KNOX AND AMERICAN II

RESPONSES in red

TITLE SHEET
DRC-Title

BUILDING ELEVATIONS
DRC-2.1

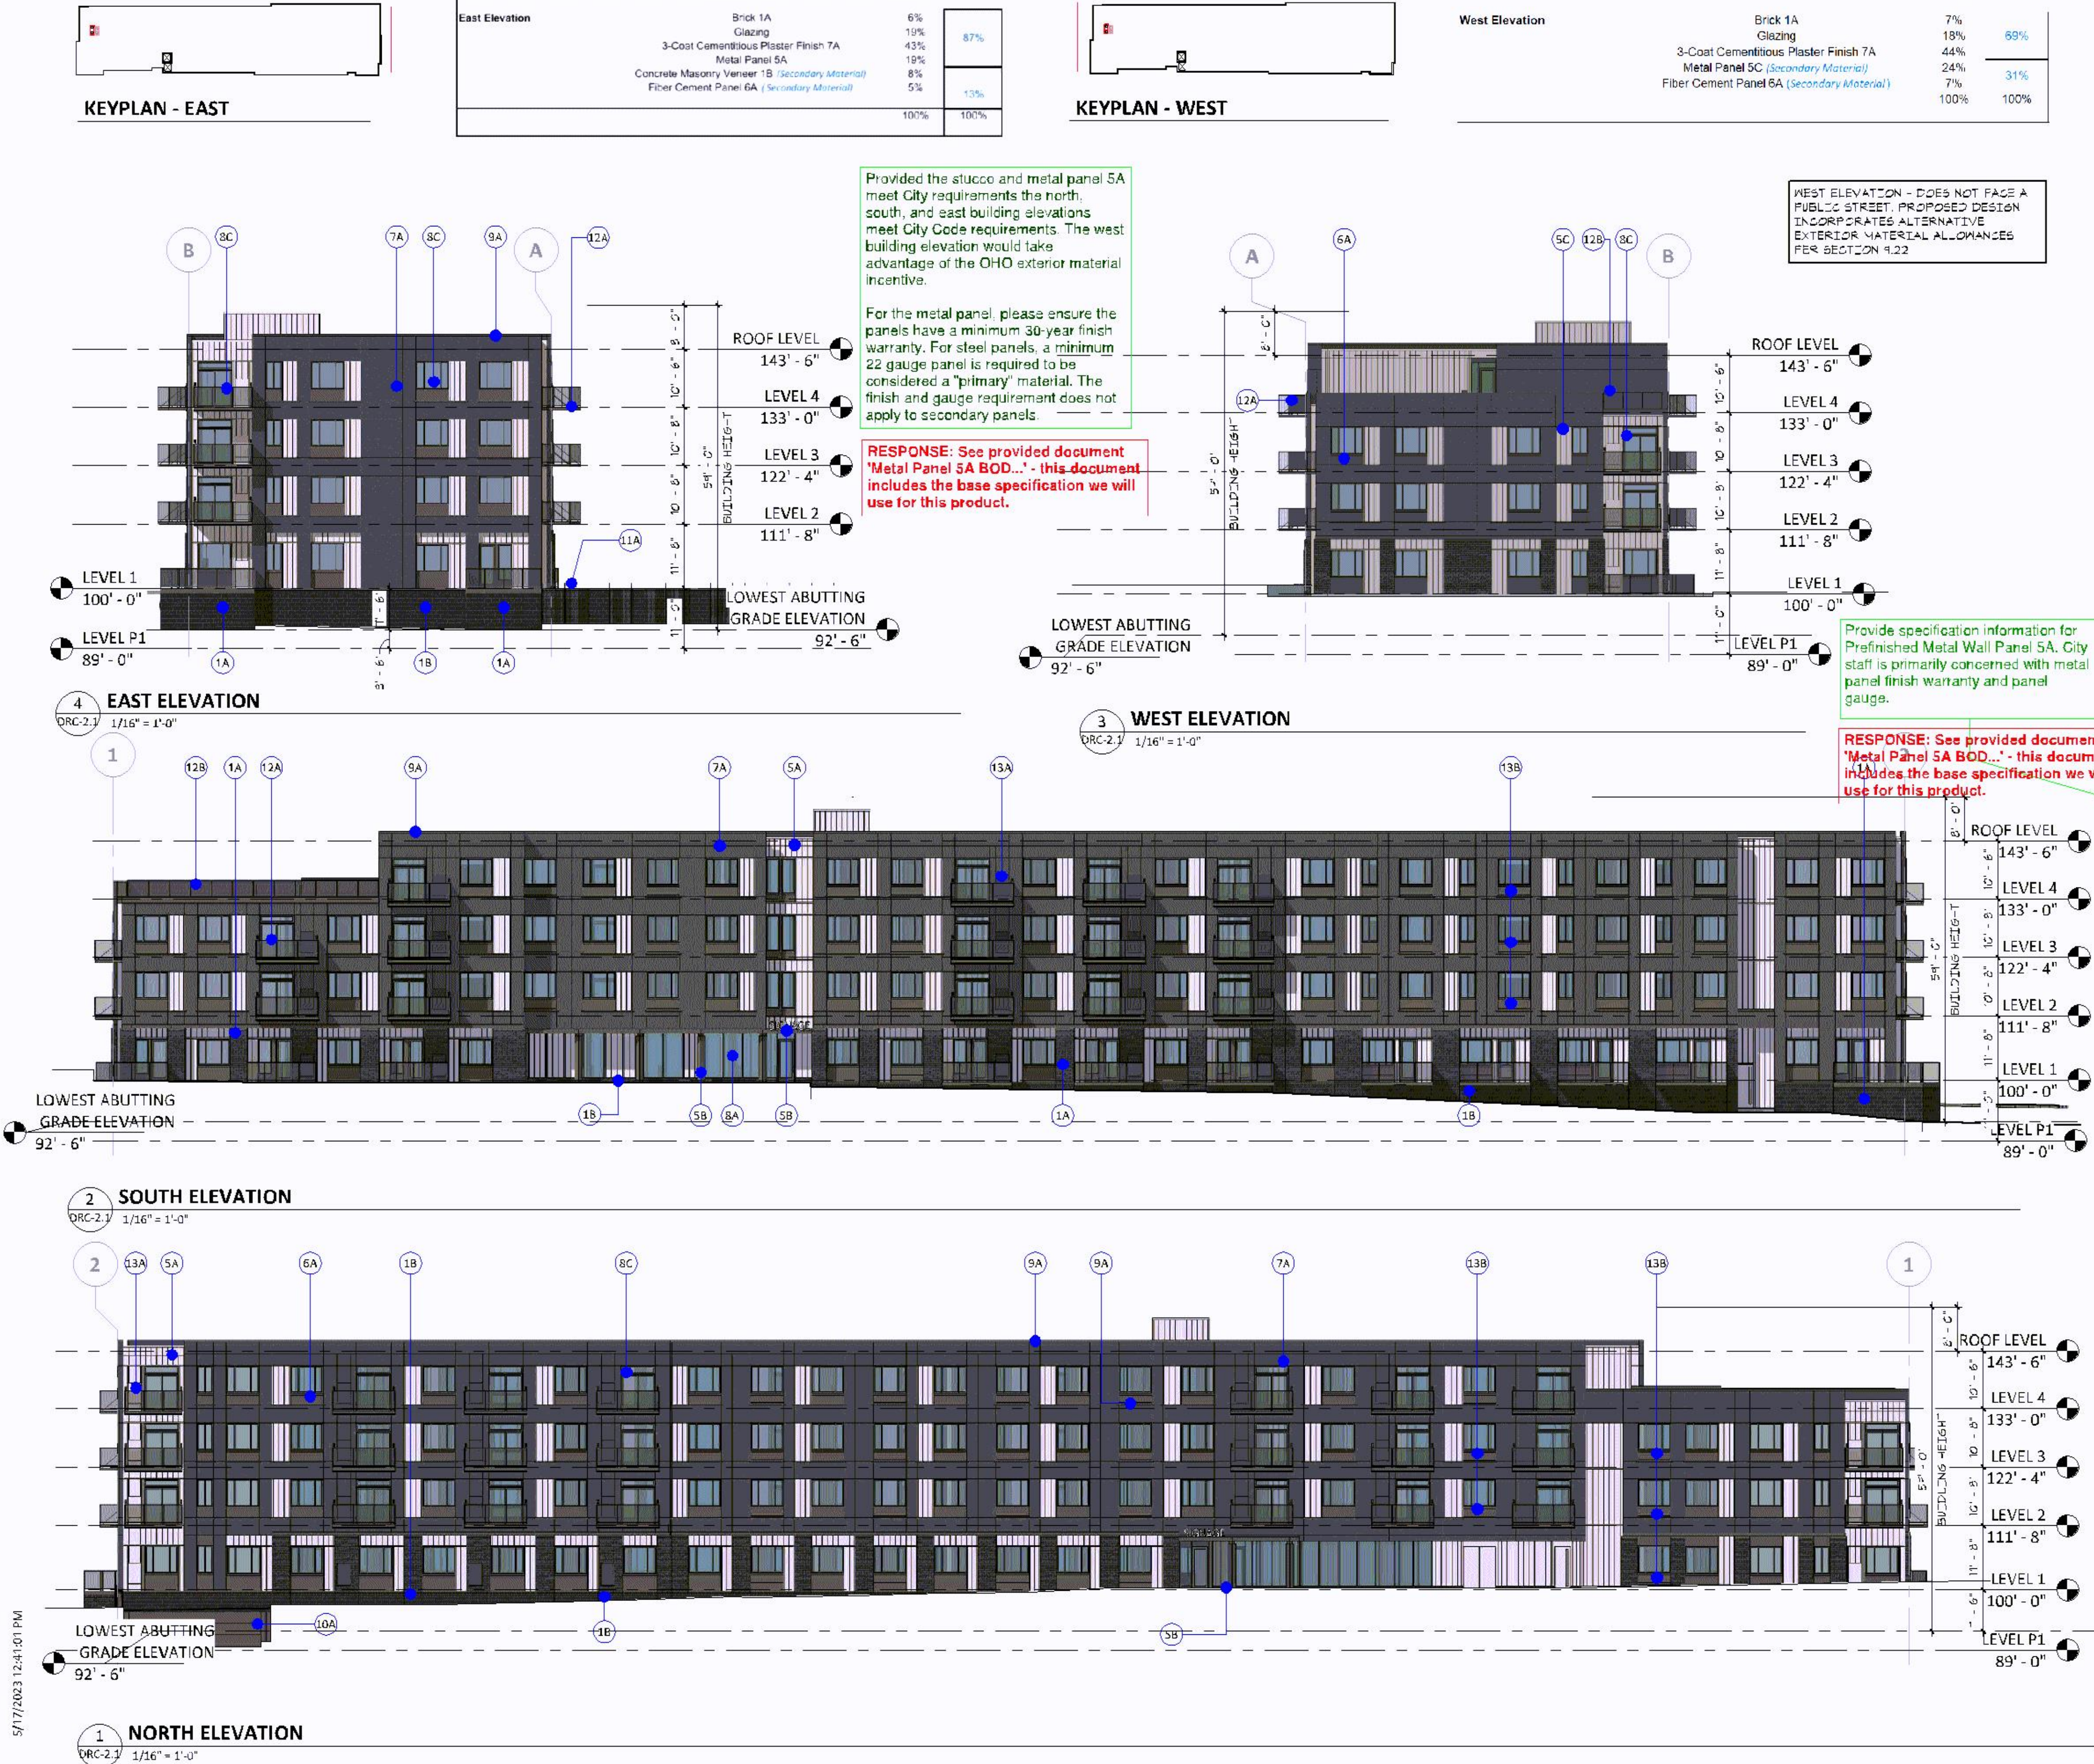
For the metal panel, please ensure the panels have a minimum 30-year finish warranty. For steel panels, a minimum 22 gauge panel is required to be considered a "primary" material. The finish and gauge requirement does not apply to secondary panels.

Provide specification information for Prefinished Metal Wall Panel 5A, City staff is primarily concerned with metal panel finish warranty and panel gauge.

RESPONSE: See provided document 'Metal Panel 5A BOD...' - this document includes the base specification we will use for this product.

RESPONSE: See provided document 'Metal Panel 5A BOD...' - this document includes the base specification we will use for this product.
